BLUE RIVER PLANNING AND ZONING COMMISSION MEETING MONTH

TO: Michelle Eddy, CMC/CPM - Town Manager/Clerk
FROM: Kyle Parag, Plan Reviewer - CAA
DATE: June 26, 2025
RE: Planning/Zoning/Architectural Guidelines review – 0016 Rustic Ter

MUSZYNSKI HOUSE

RESPONSE TO PLAN REVIEW JUNE 26, 2025

SITE PLAN
SCALE: 1" = 10.0'

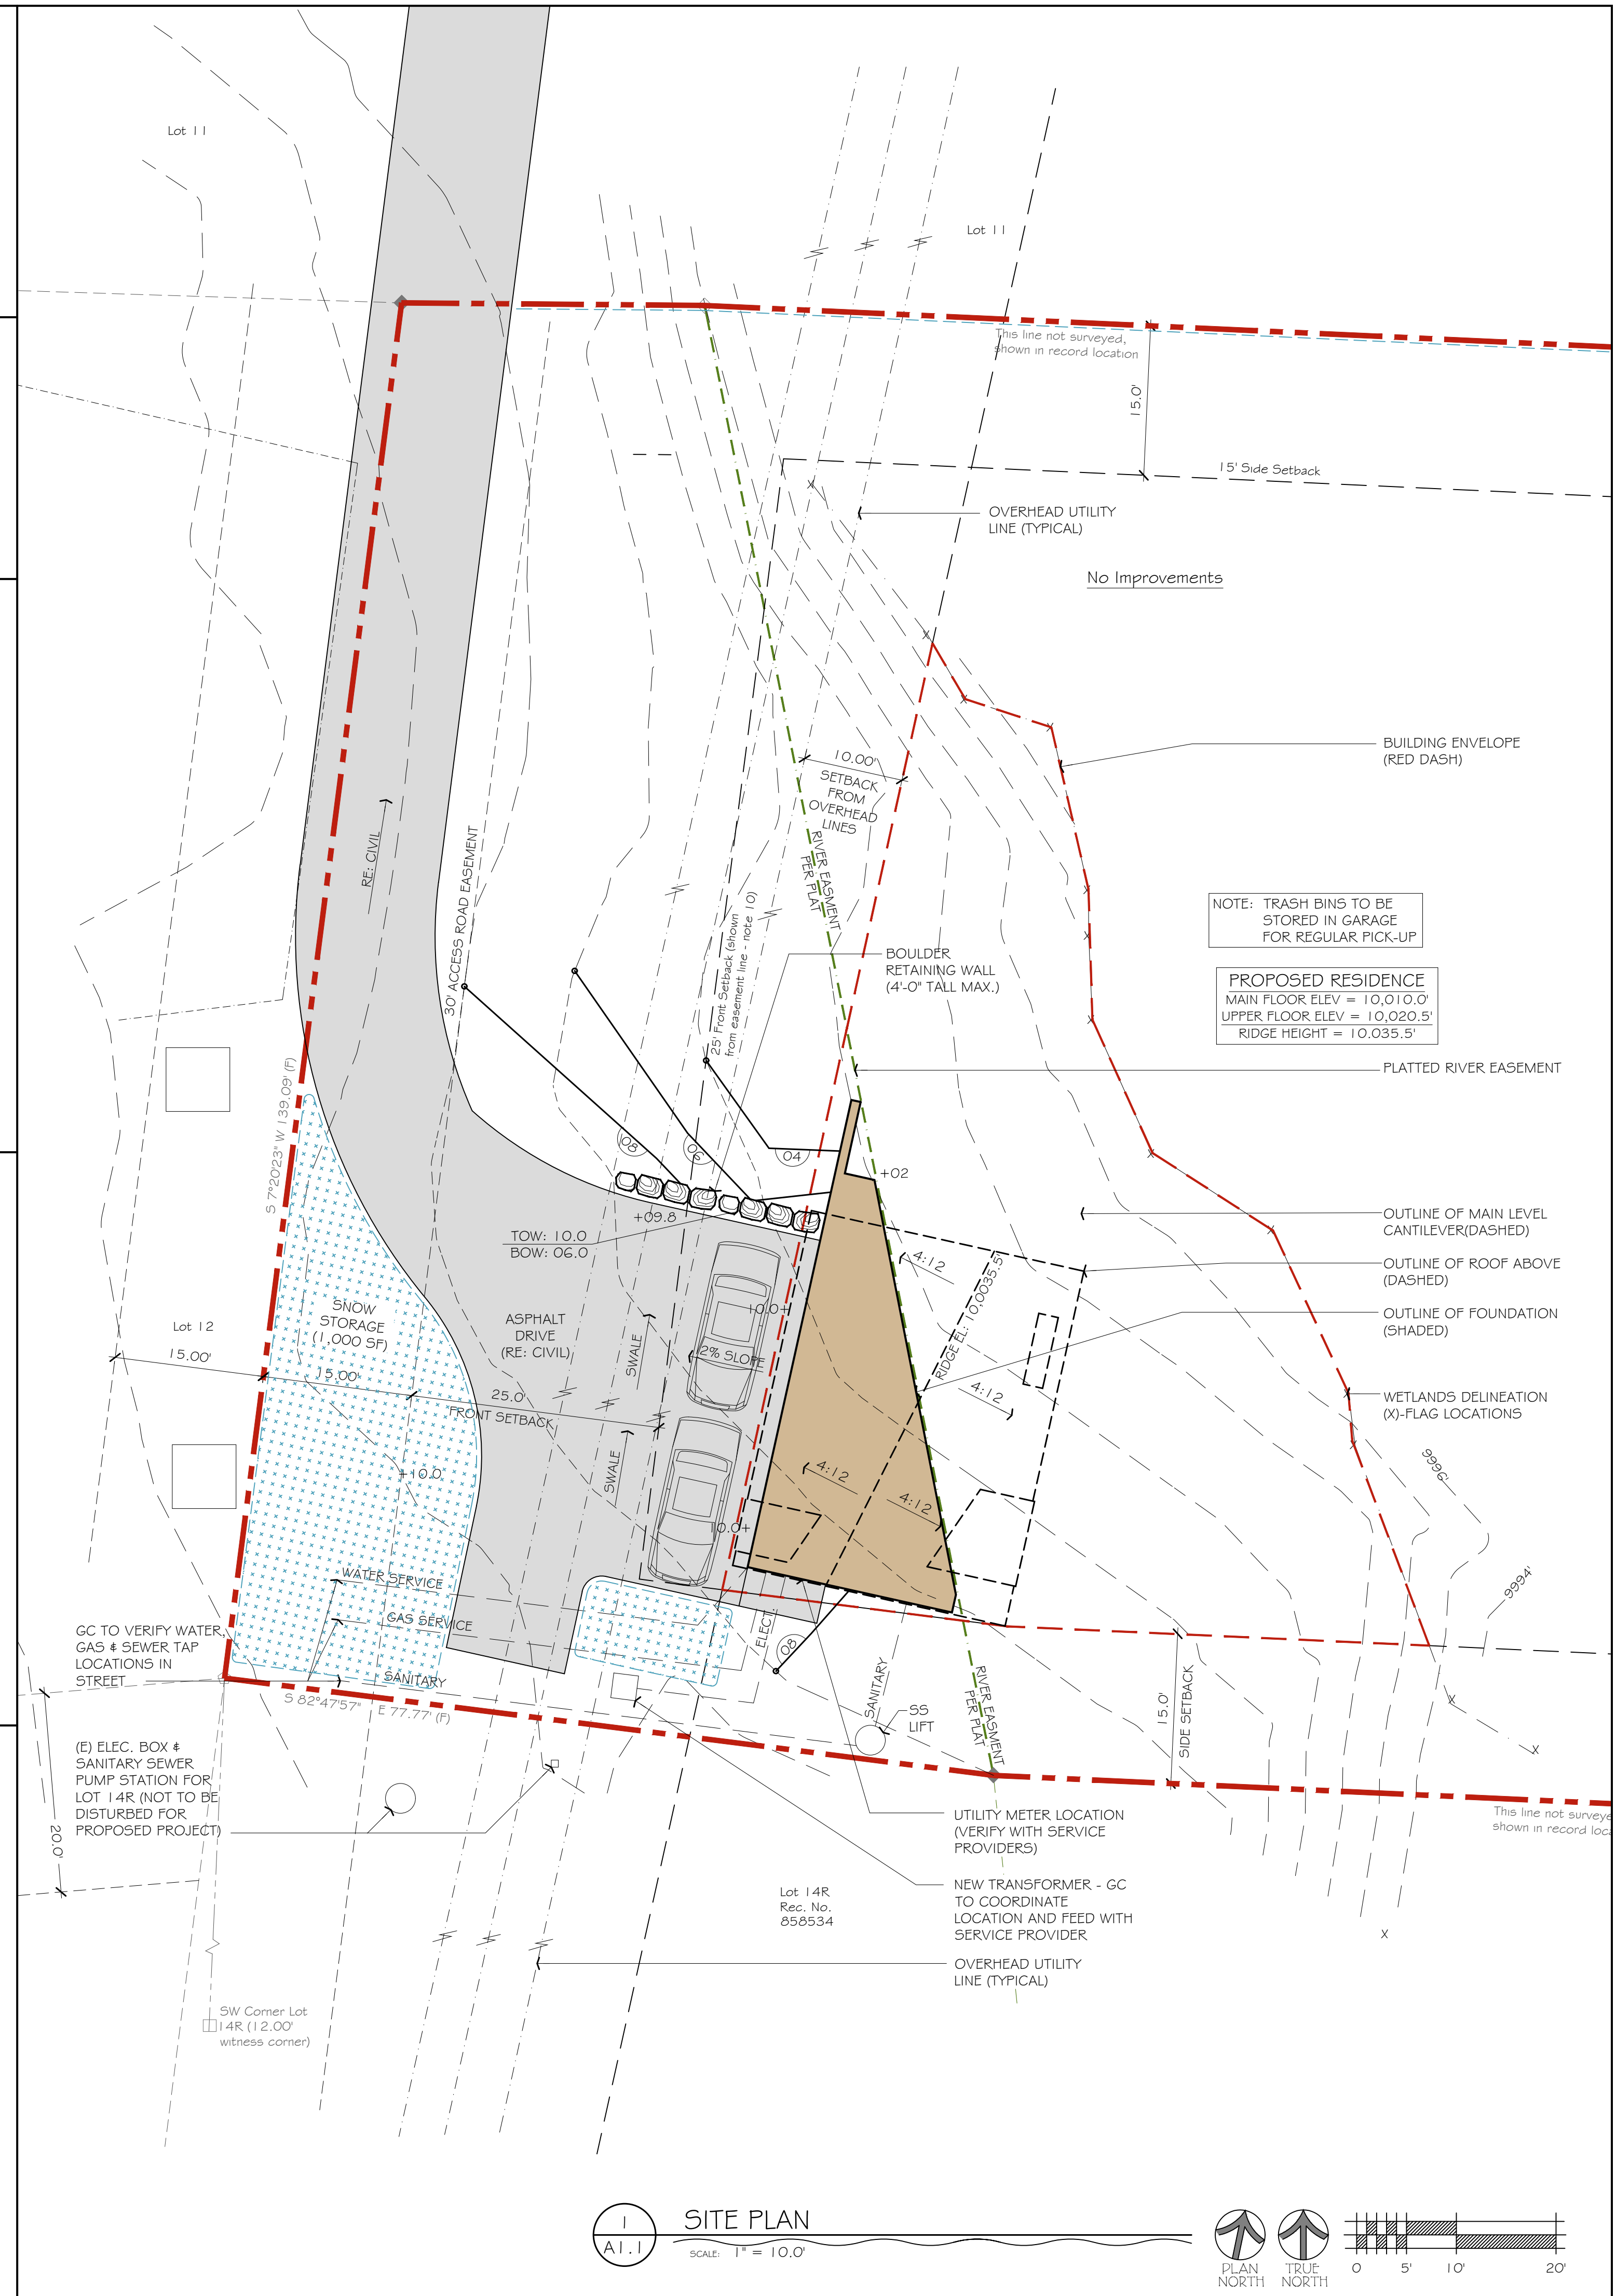
Setbacks: Proposed principal residence does comply with required setbacks based upon submitted docs.

STANDARD	NOTES/REMARKS	SUBSTANTIAL COMPLIANCE
DEVELOPMENT STANDARD		
Article 3: Easements	Easements are indicated. Easements include a subdivisional plat note for river easement. The building cantilevers into that easement, but the footprint does not violate that easement. Electrical easement exists on the property as well, the plans indicate the powerlines are 10' in front of home. Clarified that 10' from existing lines are adequate from Xcel. Please review 16B-4-30 (b)(4), indicates surface use.	Y
Article 4: Buildable Area/setbacks	The road does not currently exist to measure the setback from, so the road access easement line is indicated as the measurement point. 25' is indicated. The south setback is indicated as 15'	Y
Article 5 Building Design Standards		
Article 5-20 Building Height	Height is indicated at 35', scaled per our definitions at 32'	Y
Article 5-60 Foundation	Foundation is not exposed, covered in stone veneer	Y

Type	Item	Note from Planning	Response
	Setbacks	Proposed principal residence does not comply with required setbacks based upon submitted docs. South overhangs encroach into setbacks	<p>The last set of plans that was approved had a small section hanging over into the side.</p> <p>This is being updated to comply from our architect to adjust the roof overhang and that exhibit will be sent over today in response to your comment</p>
	Parking Standards	Parking requirements do not comply. One space provided via garage, the remaining 2 spaces would be provided in front setback	<p>We are revising the site plan to show the two exterior parking spaces outside of the front setback as requested.</p> <p>Per your letter that plan will be provided today</p>
PC	Article 3 Easements	The powerlines are 10' in front of the home. Unclear to the actual easement utility company wants or has obtained, Please review 16B-4-30(b)(4)	We have spoken to Xcel about compliance with our design and their requirements. See attached letter. As long as we are 10' off the powerline wit the building we comply

Article 4: Buildable Area / setbacks	The road does not currently exist to measure the setback from, so the property line is indicated as the measurement point. 25' is indicated. The south setback is indicated at 15' but the overhangs encroach into the setback which is not permitted per	<p>The last set of plans that was approved had a small section hanging over into the side.</p> <p>This is being updated to comply from our architect to adjust the roof overhang and that exhibit will be sent over today in response to your comment</p>

A1.1

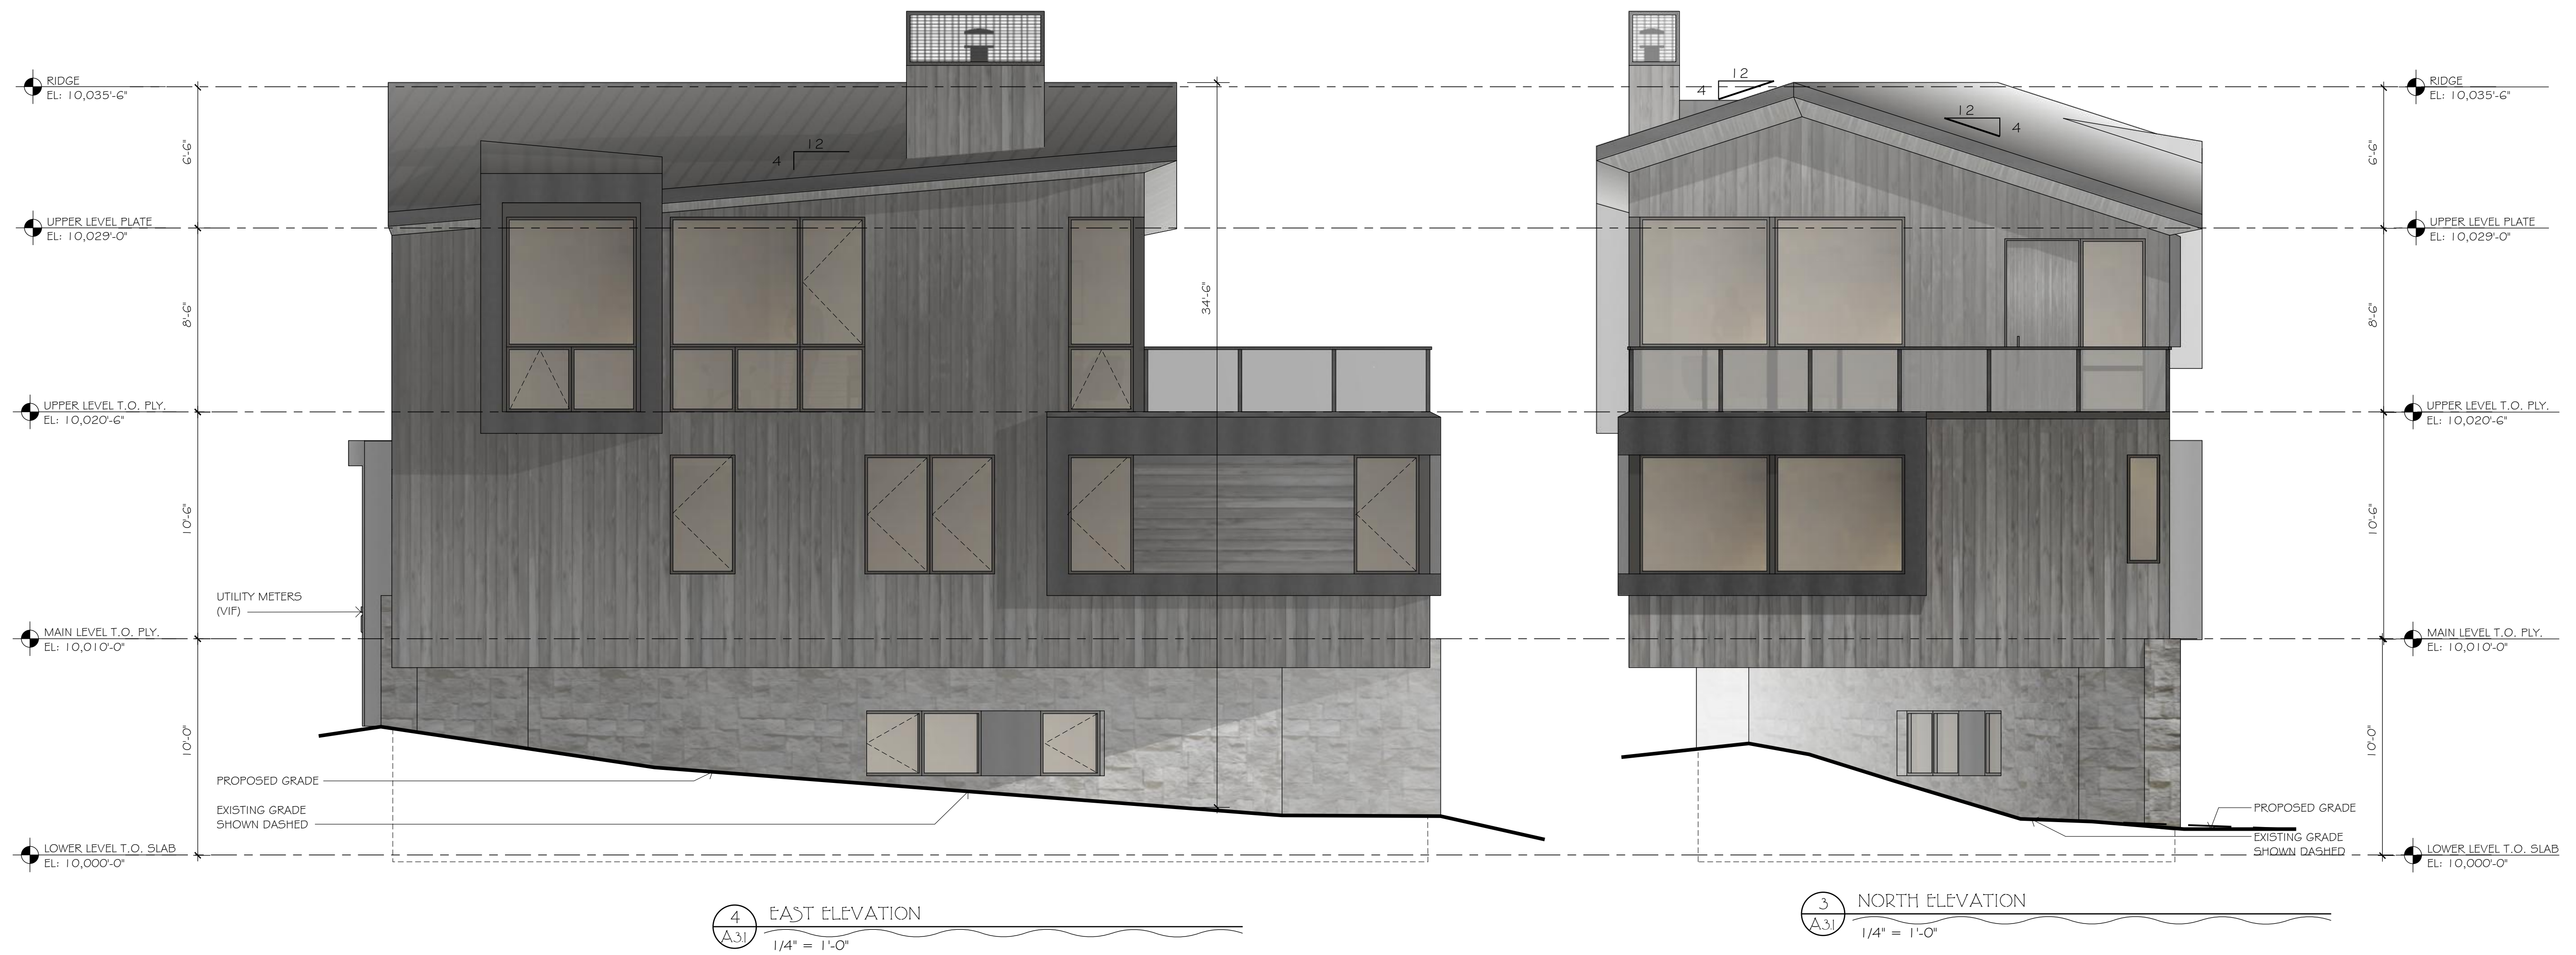
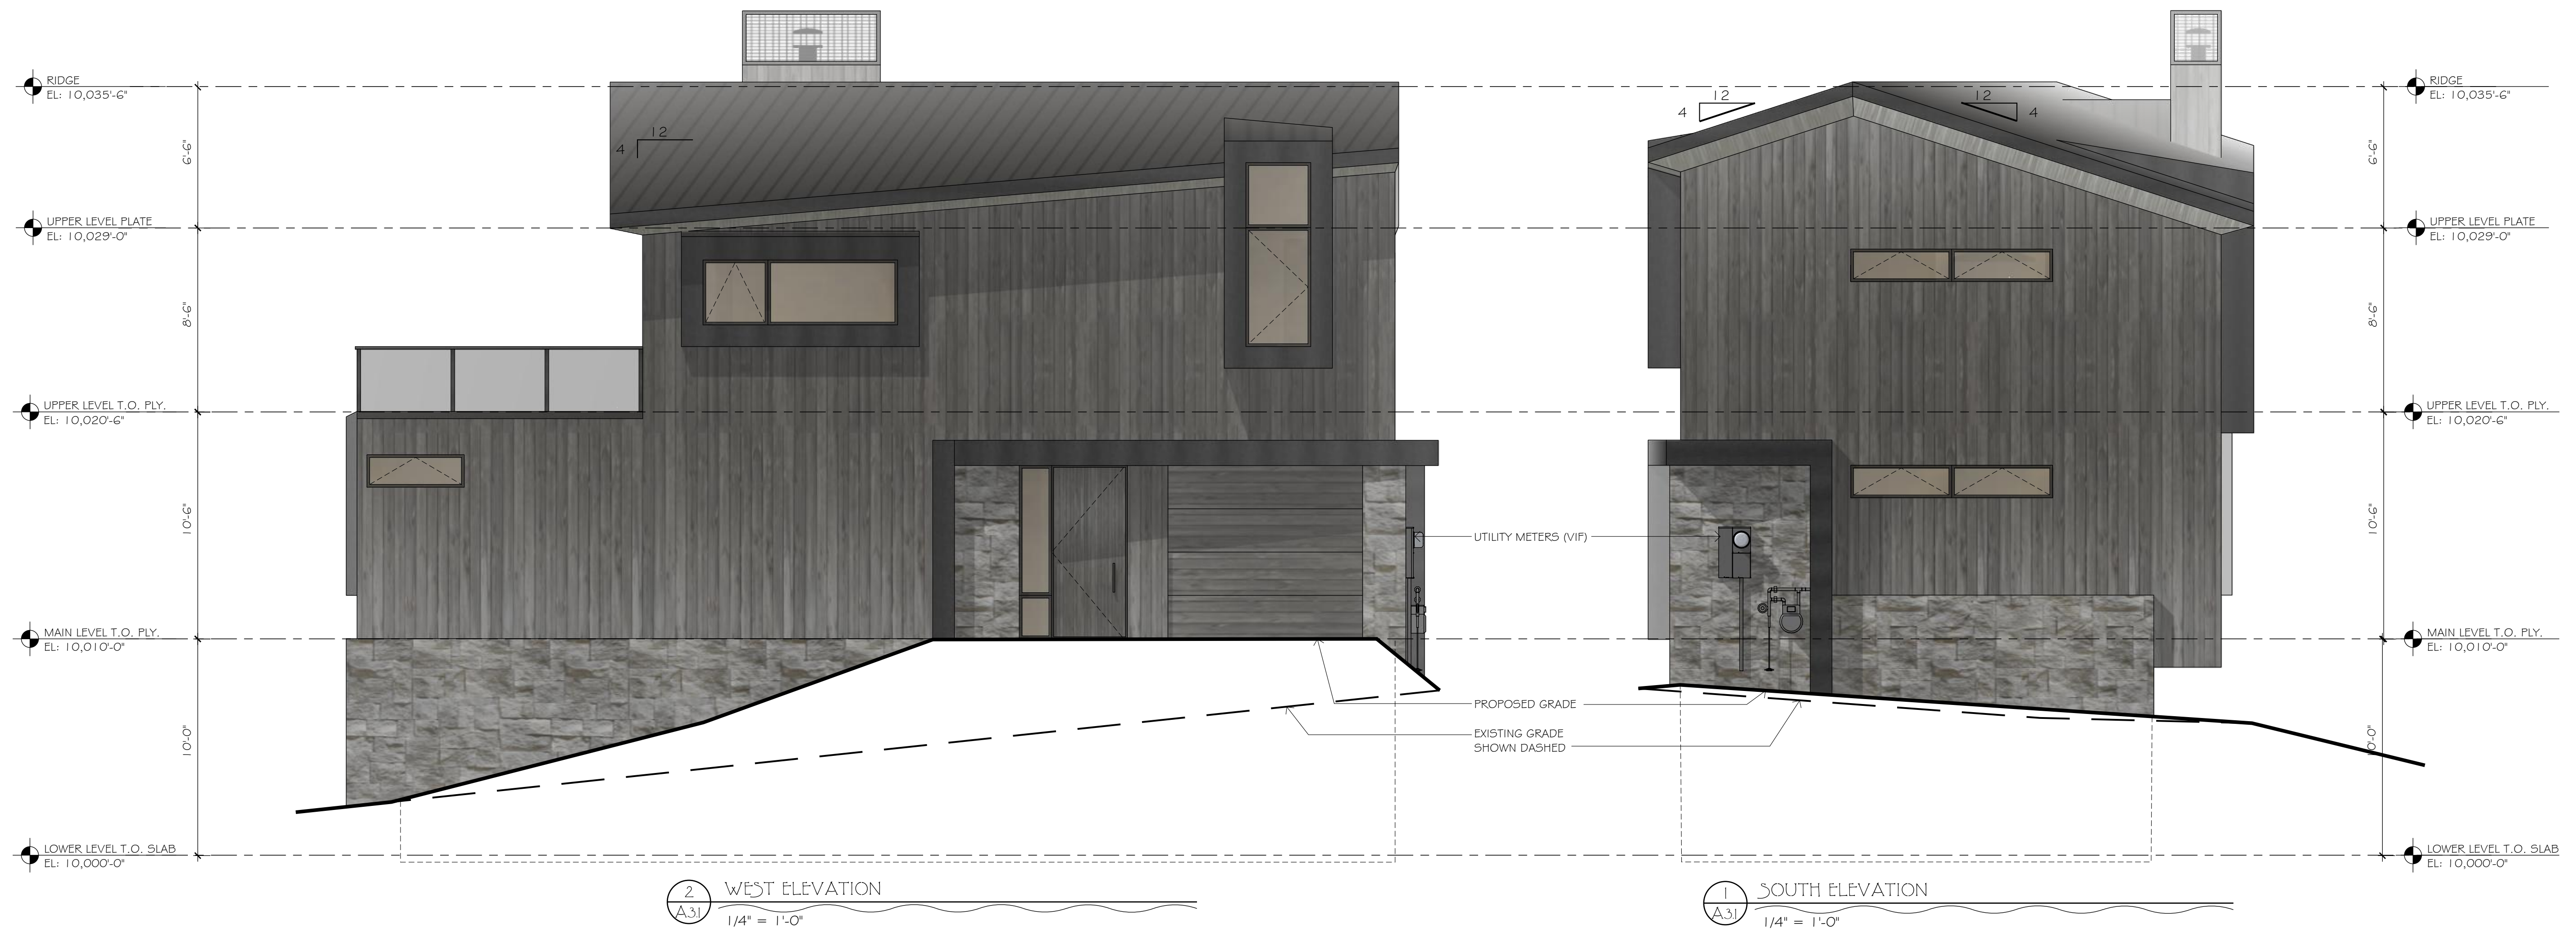
Article 5-70	Main roof design is a gable roof with a slope of 4:12.	Y

Roofs	Facia material has been clarified as wood	
Article 5-80 Garages	Garage door matches the home colors and design and the garage is subordinate to the home.	Y
Article 5-90 Window and doors	Windows are sized to complement the home, front door is not too substantial.	Y
Article 5-100 Balconies and railings	Metal with glass is indicated	Y
Article 5-110 Chimney and Roof Penetrations	Chimney is indicated, substantial portion of the home, indicated to match materials of the walls, and incudes a large cover. Cover has been indicated to be painted roof color, per 16b-5-110	Y
Article 6 Building Materials and Colors		
Article 6-20 Materials	Siding is vertical siding 1x6	Y
Article 6-30 Colors	Colors are provided and show general compliance	Y
Article 7 Accessory Improvements		
Article 7-(20-40, 110) Berms, Garages, sheds and Gazebos	None indicated. Garage is indicated at 294 Sqft	Y
Article 7-50 Driveways	Width indicated at 14'. Slopes are not indicated, but expected to be low. First 10 feet of the driveway are not indicated, as they are beyond property line, clarified with designer they will comply. Road access easement connects to property, the driveway will extend through the easement.	Y

PC	Article 5-70 Roofs	The use of metal fascia is prohibited per 16b-5-70(c)(3) unclear if that is proposed	No metal fascia is shown, and none will be used. This is wood
	Article 5-110 Chimney and Roof penetrations	Chimney includes a large cover. Unclear if cover meets requirements of 16b-5-110(a)	Sec. 16B-5-110. Chimney and Under the same section it says All exposed penetrations, pipes and flues shall be painted to match the roof color. That is what is shown – the steel cage will be painted the same as the roof color.
PC	Article 7-50 Driveways	Width indicated at 14'. Slopes are not indicated but expected to be low. Exceeds allowable 12' in first 10 feet	In response to your comment from today, architect will work to address in update coming today
	Article 7-60 Parking Areas	Parking comprises of 1 interior spaces and 2 exterior spaces. The exterior spaces are in the front setback. 3 spaces are required 16b-7-60(d)(1)	We are revising the site plan to show the two exterior parking spaces outside of the front setback as requested. Per your letter that plan will be provided today
